PM9A1 FW Change Notification

2022. Nov

Memory Business, Quality Assurance Division

- **Purpose : Samsung PM9A1 NVMe SSD F/W Change to 78 version**
- **Reason of change**
 - Fix side effect of 77version FW (* Samsung officially informed to hold 77ver)
- **Samsung internal schedule**
 - Samsung internal Qualification : Nov-16th-2022
 - Release schedule : : Nov-16th-2022

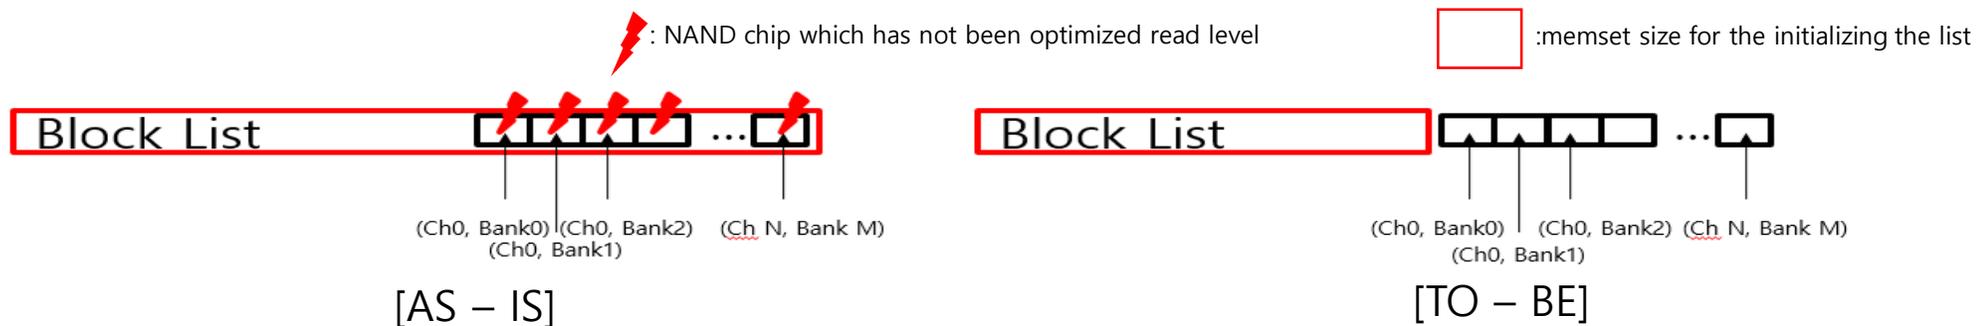
■ Issue: High power consumption observed at Modern Standby

■ Root cause

- It is verified to be side effect of 77 FW item which is 'Improve FA debug feature: Support UART feature'
- While trying to enter power mode, FW mis-knew as if host UART command is triggered and stopped to enter power mode, and this increased power consumption

■ Corrective Action

- Fix the wrong setting for FW mis-knew

[Fig 1]

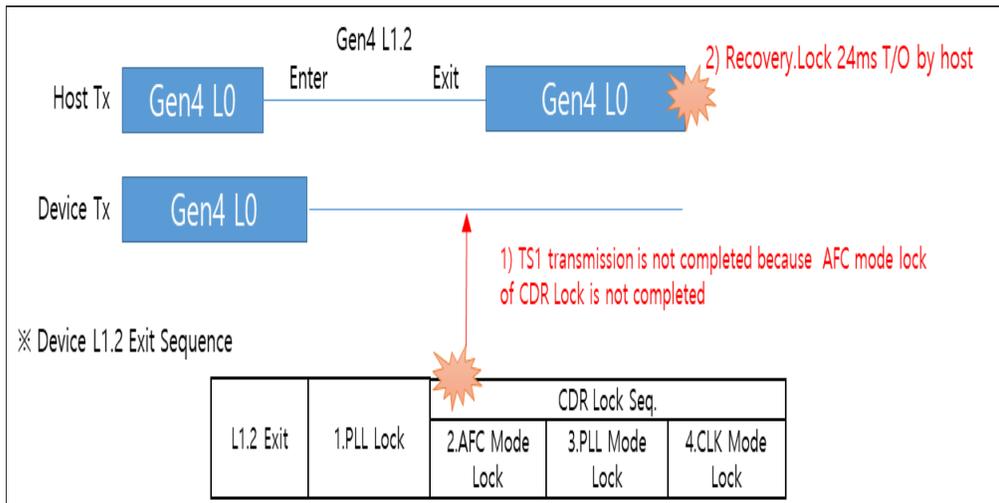
■ Issue

- Found Recovery.Lock 24ms Timeout when exit L1.2 during Modern standby testing

■ Root cause (failure mechanism)

- Device couldn't send TS1 (training Sequence 1) to Host and finally Recovery.Lock 24ms Timeout occurred and Link down happened
- When exit L1.2, CDR (Clock and Data Recovery) Lock of CTRL is not properly completed [Fig 1]
- The slow completion of VCM(Reference voltage of VCO in AFC circuit) settling was observed with very low probability during the AFC Sequence
- VCO(Clock oscillation circuit) malfunctioned due to the slow completion of VCM settling at fail samples

■ Corrective action

- Improvement Action

- Team added W/A point to improve AFC circuit malfunction

- ✓ Add 2 times AFC circuit retry code when AFC circuit work abnormally

So, If AFC circuit work abnormally, the FW initializes AFC circuit after 10ms and 15ms

[Fig 2]

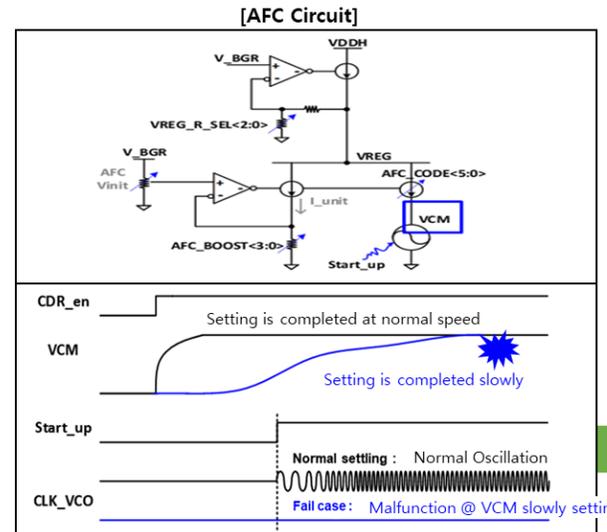
[Fail Mechanism]

- 1) SSD exit L1.2
- 2) VCM settling slowly during AFC @ Fail samples
- 3) VCO oscillator malfunctioned due to VCM settling
- 4) Can not meet target Frequency during AFC

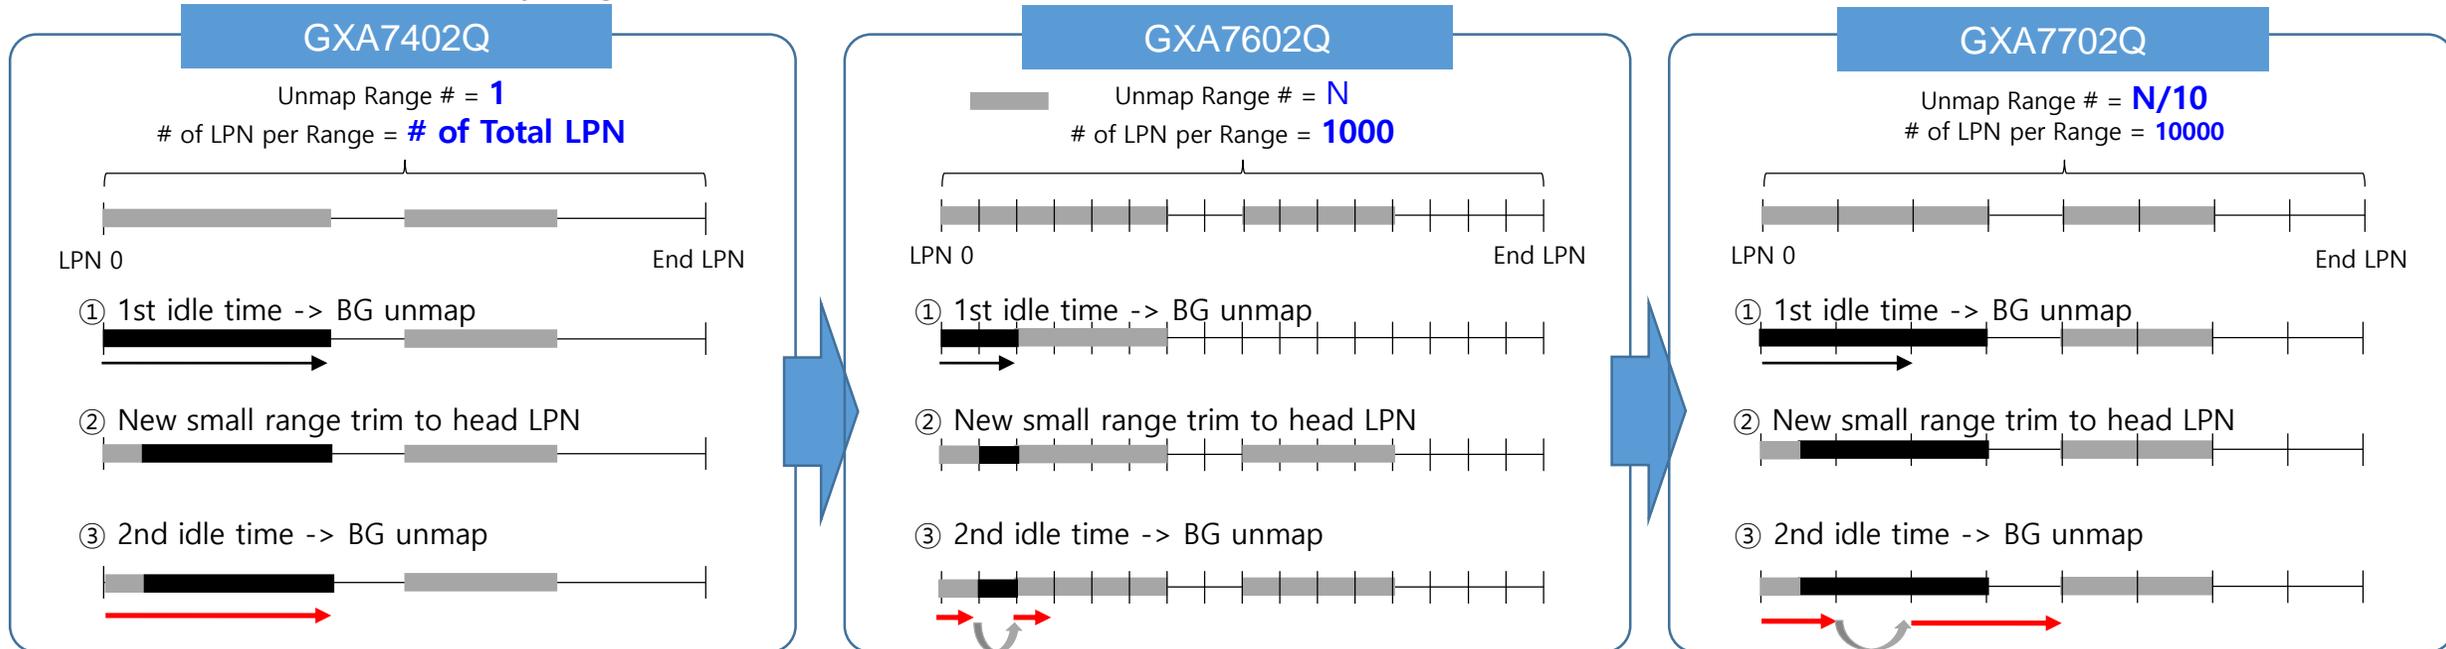
■ Issue

- SW encryption time takes so long

■ Root cause

- It is related to side effect from previous Change item(Unmap process optimization)
- Splitting # of LPN per Unmap Range was essential to guarantee to enter PM, but # was excessively small @ GXA7602Q
- FW handling time for Unmap are lengthened → Free Blocks are generated more slowly
→ Ratio of unnecessary Migration & TLC write is increased

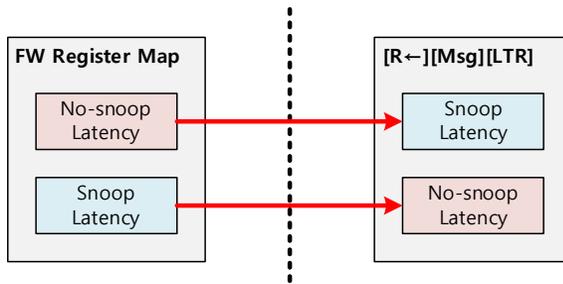
■ Issue

- Seq Write performance was dropped after long idle

■ Root cause

- In DSB Off state, Foreground SSB Compaction(a kind of garbage collection) is executed to receive all write data from CDM to SSB as SLC area.
- FW checks the existence of the target block for F/G SSB Compaction in the process of checking whether there is a target SSB to perform F/G SSB Compaction after Exit PM – (Select list for Victim block)
- But FW removed the target block checked from the Compaction Victim List.
- SSB Free block cannot be created because the target block is not selected as Victim of F/G SSB Compaction,
- Finally, TLC write occurred because SSB doesn't have a room for write during CDM and Seq write performance showed TLC performance

■ Corrective action

- When exit PM(power management mode), FW only check whether the F/G SSB Compaction Victim exists and do not remove it from the list.

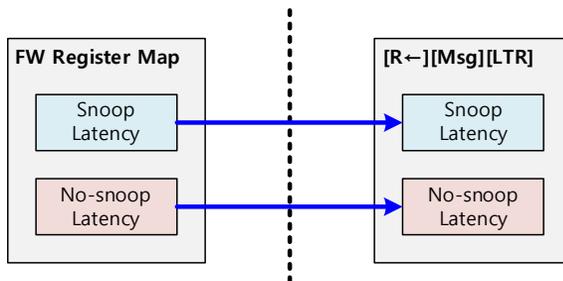
■ Issue

- LTR Latency value Register was reversed

■ Root cause

- Register mapping related to Snoop/No-snoop latency of device FW Header was reversed.

■ Corrective action

- Header file of Device FW is fixed.
